Received  
WILLIAMSON COUNTY, TEXAS  
CHANGE ORDER NUMBER 1

Project: 1904-285  
Roadway: CR 176 at RM  
2243  
HNTB Corporation  
Round Rock

**4B: Third Party Accommodation. Third party requested work.** This Change Order adds relocation of the existing Brushy Creek Municipal Utility District (BCMUD) water line along CR 176 and revises the City of Georgetown water line relocations on the project.

WILLIAMSON COUNTY  
CR 176 AT RM 2243 INTERSECTION  
COG AND BCMUD WATER ADJUSTMENTS  
AND BCMUD 24" RAW WATERLINE RELOCATION

PIPE ENCASEMENT DETAIL

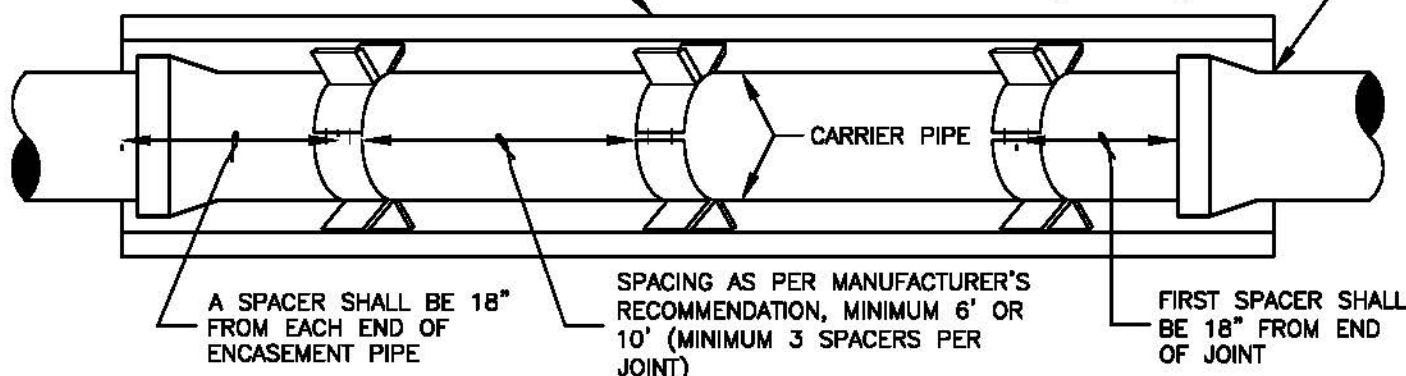
The relocations for BCMUD include installing a new portion of water line in an encasement because the new roadway crosses the water line and adding a 4" Combination Air Release Valve Assembly (CARV), salvaging the old CARV and removing the existing 4" Gate Valve. The revisions to the City of Georgetown water line include adjustment of the existing 2" line and deletes items to adjust the existing 4" water line.

**SHEET C-101**  
5 of 10

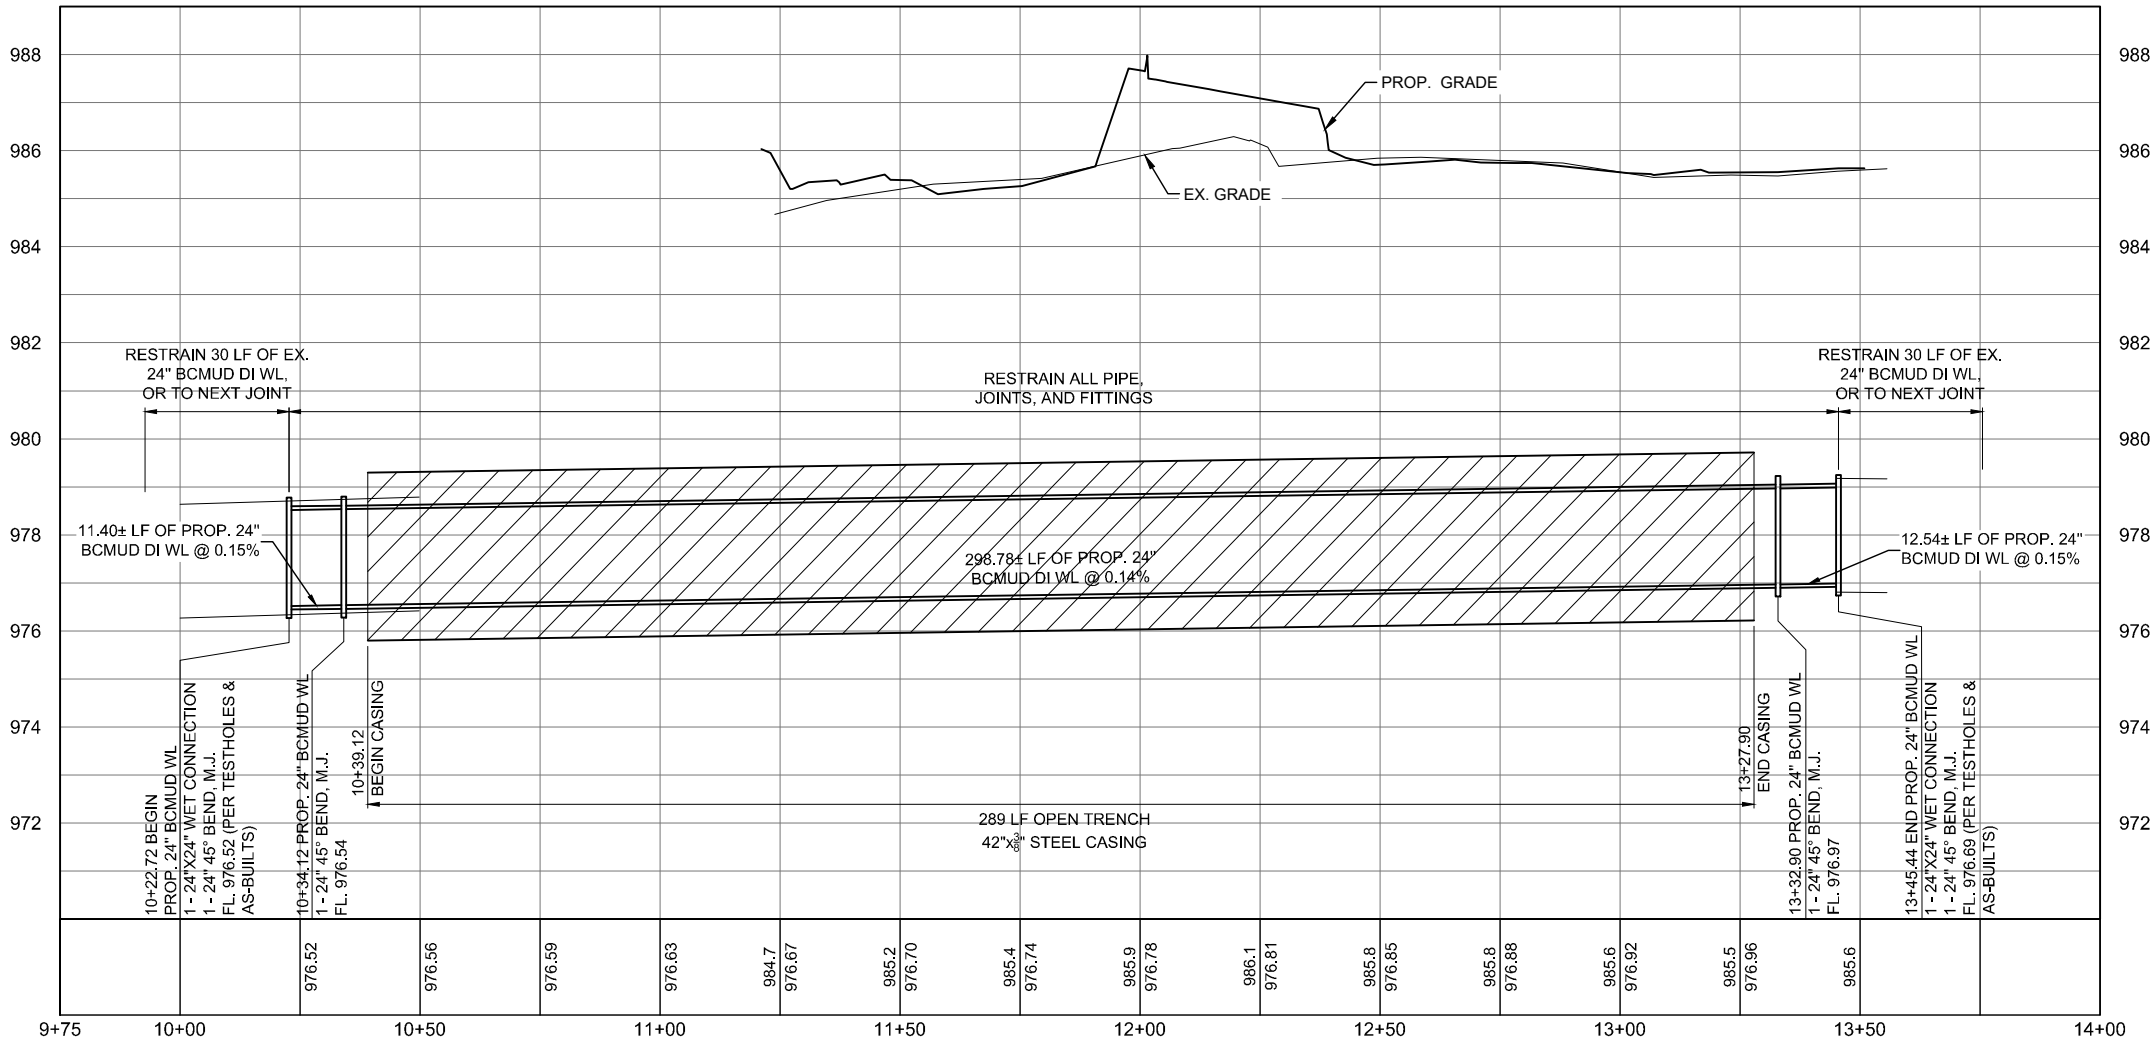
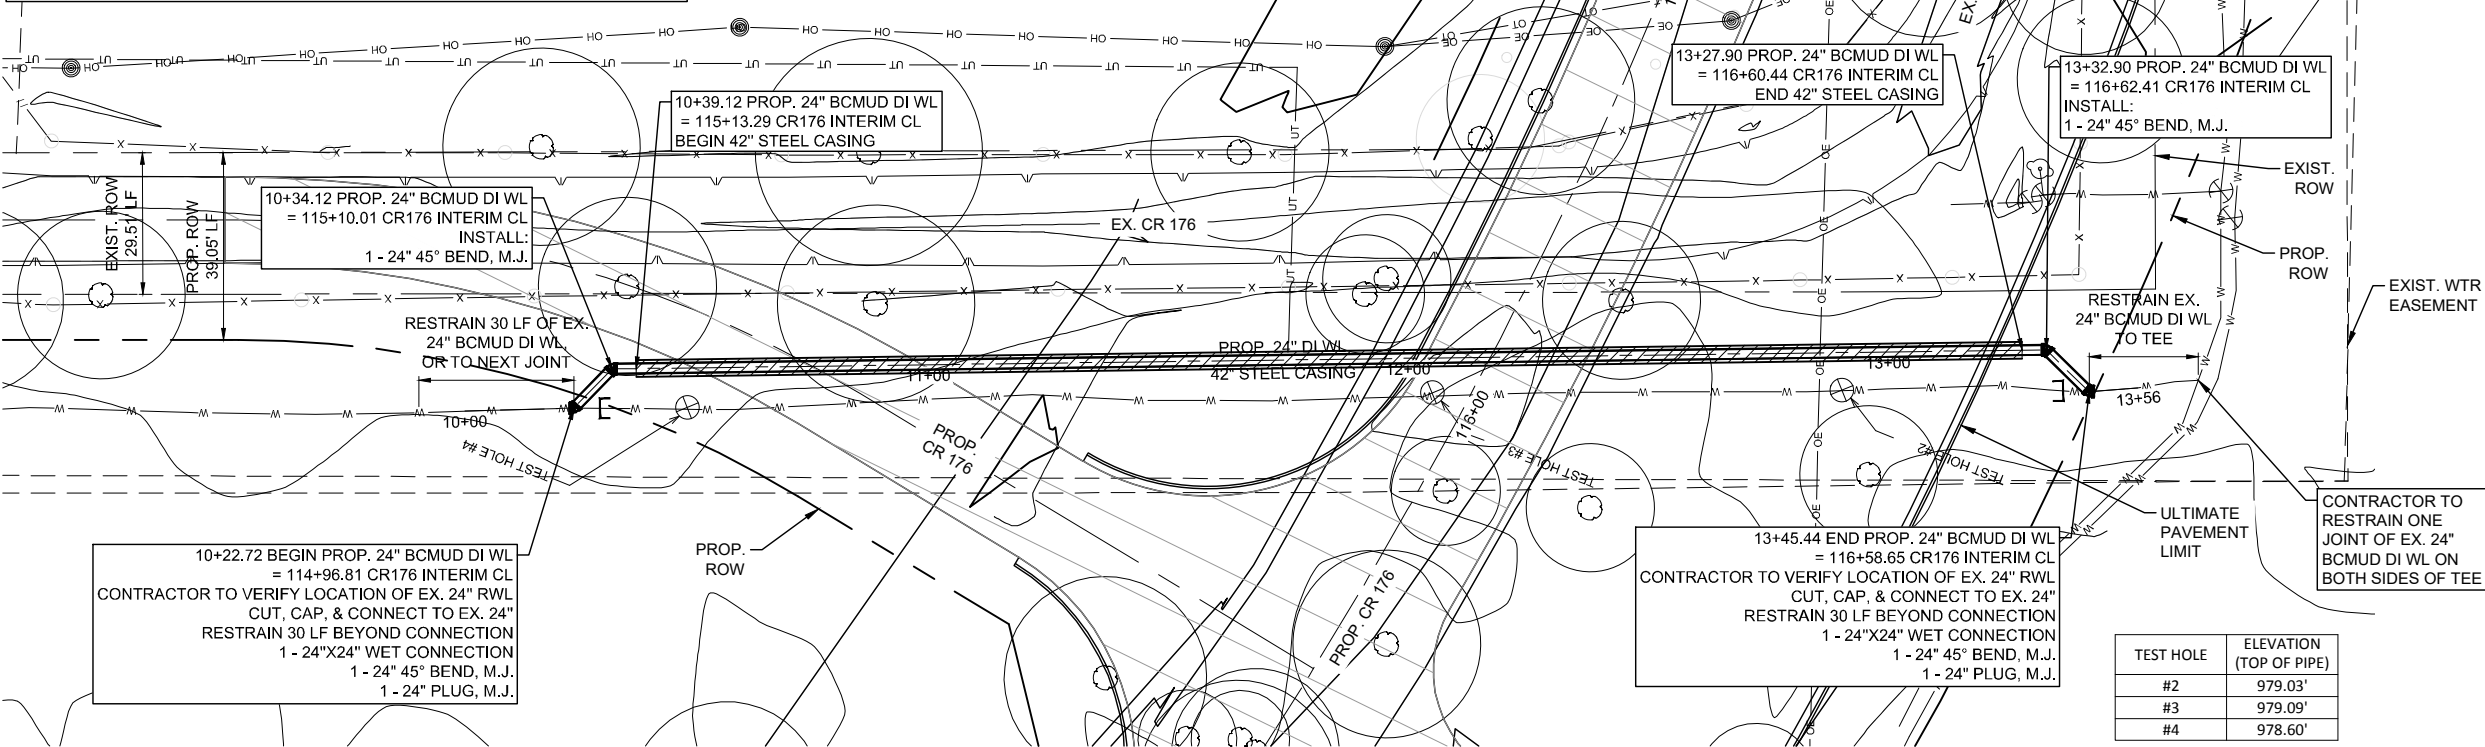
This Change Order adds relocation of the existing Brushy Creek Municipal Utility District (BCMUD) water line along CR 176 and revises the City of Georgetown water line relocations on the project.
